Economic Commission for Europe**Inland Transport Committee****World Forum for Harmonization of Vehicle Regulations****Working Party on Lighting and Light-Signalling****Eightieth session**

UN Regulations Nos. 37 (Filament lamps), 99 (Gas discharge light sources), 128 (Light emitting diodes light sources) and the Consolidated Resolution on the common specification of light source categories**Proposal for amendment to version [4] of the Consolidated Resolution on the common specification of light source categories****Submitted by the Task Force on Substitutes and Retrofits (TF SR)***

Figure 1
Main drawing

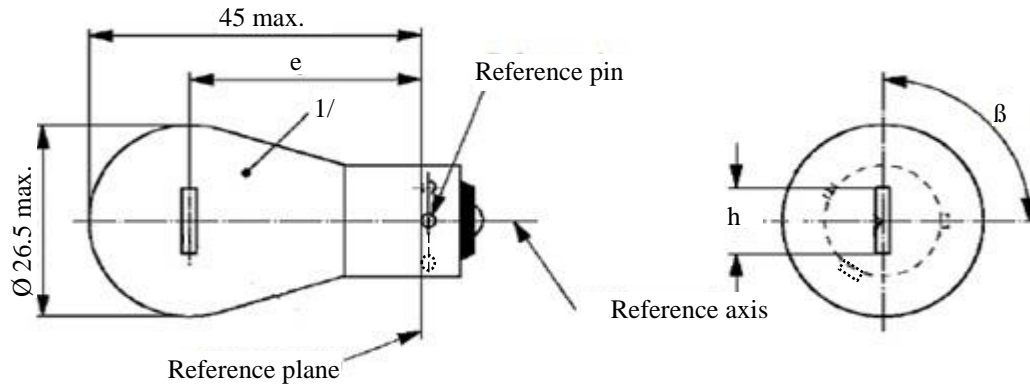
After sheet Lx5/6, insert new sheets PY21W/LED/1 to 4, to read:
(see the following pages; one page per sheet)

The drawings are intended only to illustrate the essential dimensions (in mm) of the LED light source.

Dimensions in mm		LED light sources of normal production			Standard LED light source
		min.	nom.	max.	nom.
e			31.8 ^{2/}		31.8 ^{2/}
h			9.0 ^{2/}		9.0 ^{2/}
β		75°	90°	105°	90°±10°
Cap [BAU15s-3(110°)] in accordance with IEC Publication 60061 (sheet 7004-[19A-1])					
Electrical ^{5/} and photometric characteristics					
Rated values	Volts	12	24		12
	Watts		7 ^{3/}		7 ^{3/}
Test voltage	Volts	13.5	28.0		13.5
Objective values	Watts	9 max. ^{3/}	10 max. ^{3/}		9 max. ^{3/}
	Electrical current (in mA at 9-16V DC)		150 min. 750 max.		
	Luminous flux ^{3/, 4/} (in lm at 13.5 V DC)		280 ± 20 %		280 ± 10 %
	Luminous flux ^{3/} (in lm at 9 V DC)		56 min.		56 min.

¹ The light emitted from the LED light source shall be amber.
² To be checked by means of a "Box-System"; sheet PY21W/LED/2.
³ Operated in flashing mode for 30 minutes (frequency = 1.5 Hz, duty cycle 50 per cent ON, 50 per cent OFF) and measured in the ON-state of flashing mode after 30 minutes of operation.
⁴ The value measured at elevated ambient temperature of 80°C shall be at least 65% of this value.
⁵ In case of a failure of any of the light emitting elements, the LED light source shall either still comply to the requirements concerning luminous flux and luminous intensity distribution or stop emitting light whereby/in the latter case the electrical current draw, when operated between 12 V and 14 V, shall be less than 50 mA.

Figure 2

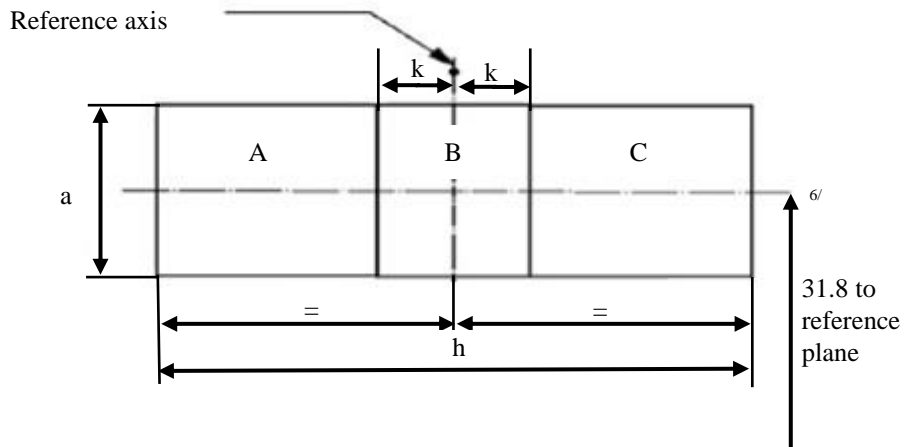
The position of the light emitting area is checked by means of a box system defined by the projections when viewing along direction $\gamma = 0^\circ$ (top view), $\gamma = \pm 45^\circ$ (inclined view) and $\gamma = \pm 90^\circ$ (front and rear view) in the plane C_0 (C, γ as defined in Figure 3).

The proportion of the total luminous flux emitted into these viewing directions from the area(s) as defined in figure 2:

- A, B and C together shall be 80 per cent or more;
- B shall be 25 per cent or more;
- A and C shall each be 15 per cent or more.

<i>Dimensions in mm</i>	<i>a</i>	<i>h</i>	<i>k</i>
Top view ($\gamma = 0^\circ$)	5.0	9.0	1.0
Inclined view ($\gamma = \pm 45^\circ$)	7.0		
Front / Rear view ($\gamma = \pm 90^\circ$)	5.0

Figure 3

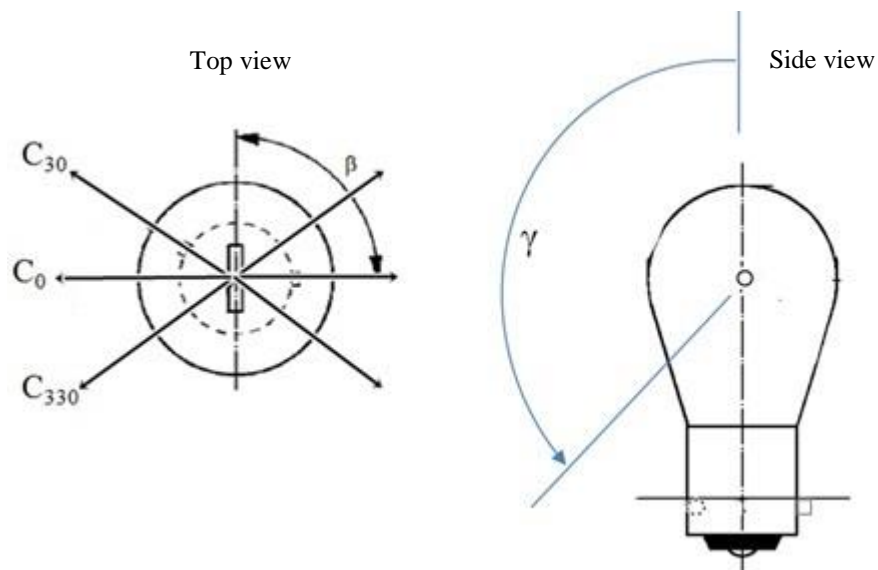
The following test is intended to determine the normalized luminous intensity distribution of the light source in the planes containing the reference axis as described in figure 3. The intersection of the reference axis and the edge of the box is used as the coordinate system origin.

The measurements shall be performed in C-planes, which contain the reference axis of the light source. The C-planes shall be C_0 , C_{30} and C_{330} . The test points for each plane and multiple polar angles γ are specified in Table 3.

The measured luminous intensity values, normalised to the measured luminous flux of the individual light source under test, shall be converted to normalised luminous intensity values of a 1000 lm light source. These data shall comply with the tolerance band as defined in Table 3.

γ	<i>LED light source of normal production</i>		<i>Standard LED light source</i>	
	<i>Minimum intensity in cd/1000 lm</i>	<i>Maximum intensity in cd/1000 lm</i>	<i>Minimum intensity in cd/1000 lm</i>	<i>Maximum intensity in cd/1000 lm</i>
-150°	60	140	80	120
-125°	60	140	80	120
-100°	60	140	80	120
-75°	60	140	80	120
-50°	60	140	80	120
-25°	60	140	80	120
0°	60	140	80	120
25°	60	140	80	120
50°	60	140	80	120
75°	60	140	80	120
100°	60	140	80	120
125°	60	140	80	120
150°	60	140	80	120

The luminous intensity distribution as described in table 3 shall be “substantially uniform”, i.e. in between two adjacent grid points the relative luminous intensity requirement is calculated by linear interpolation using the two adjacent grid points.
